DOCKETED

| Docket Number: | 19-SPPE-04 |

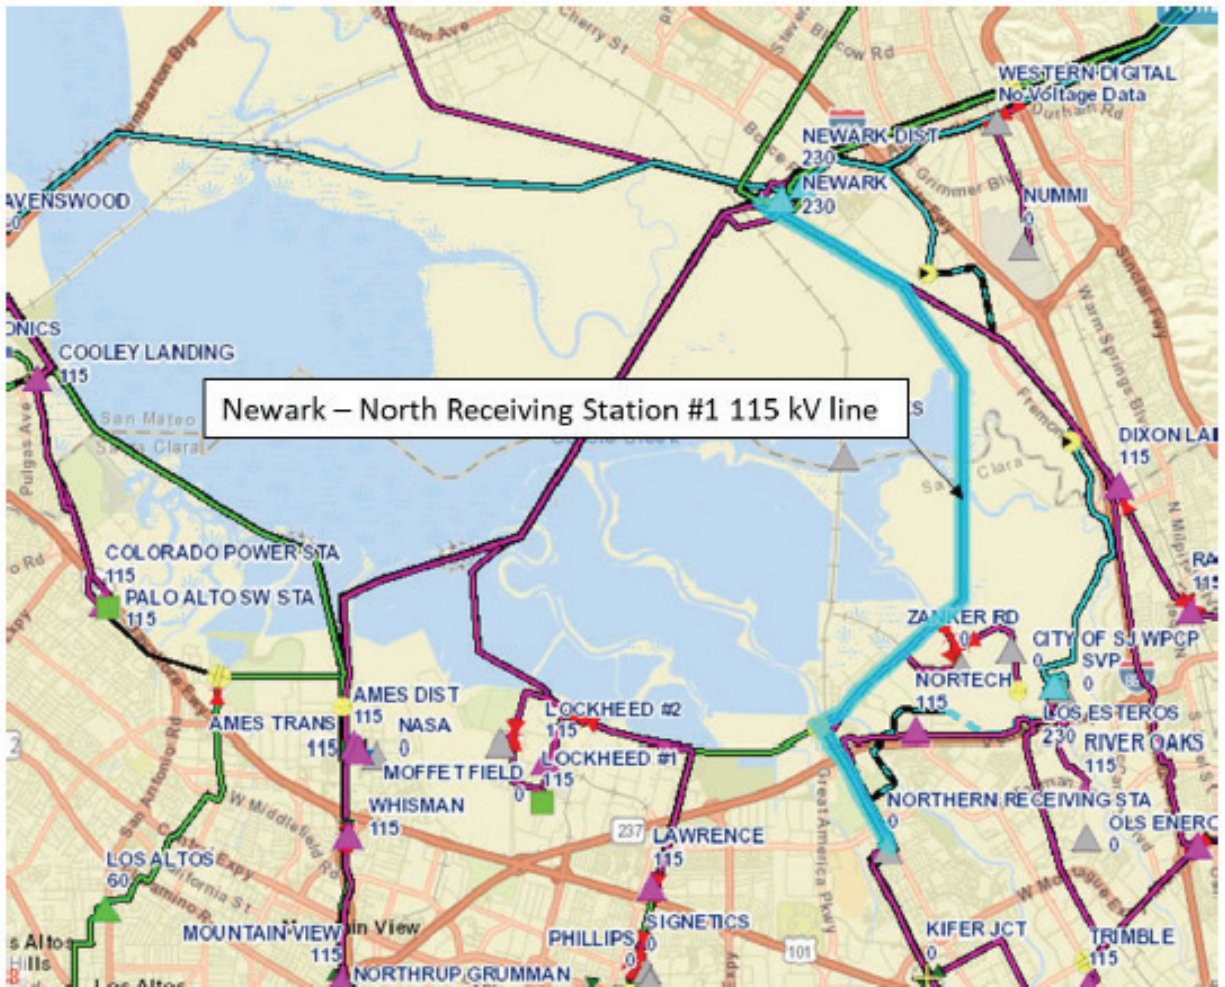
Response: The available information provided by PG&E is shown on revised Figure 2-6R. At this stage in the design, PG&E is unable to provide any additional detail in this regard.
